Authors response

“Total water vapour columns derived from Sentinel 5p using the AMC-DOAS method”

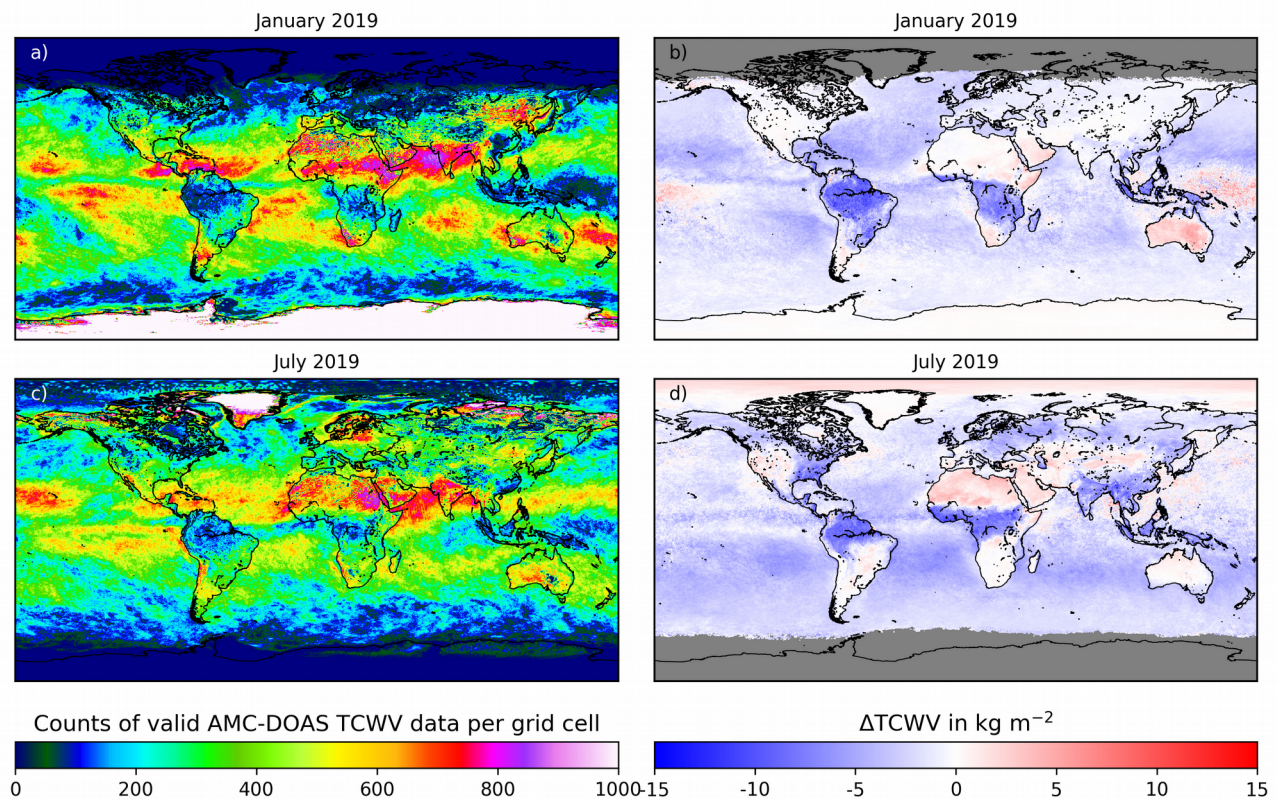
(Q18) p.24 Fig.8 Can you show the average cloud cover in this month (as proxy the number of filtered/valid observations) ? Is there a relation to negative values (e.g. in the tropical rainforest)?

(A18) The image above shows the monthly sum of the daily counted valid AMC-DOAS S5P TCWV data within one gridbox (left column). The right column shows the deviation between the

ERA5 TCWV and AMC-DOAS S5P TCWV. The counts can be used as a rough estimate of the cloud fraction filter within the tropics. Actually the negative values indeed correlate with the regions with low data availability, e.g. in the tropical rain forest. This means that probably many cloudy scenes have been filtered out. However the ERA5 data are filtered in the same way before the averaging (only collocated data are used). Therefore this should not be a sampling issue. However, this indicates that the observed differences at these regions are probably less reliable. We will mention this in the text as follows:

„The observed negative differences between ERA5 TCWV and AMC-DOAS S5P TCWV at tropical regions, e.g. tropical rain forests, correlate with regions of low data availability. We infer that these values are possibly less reliable.“
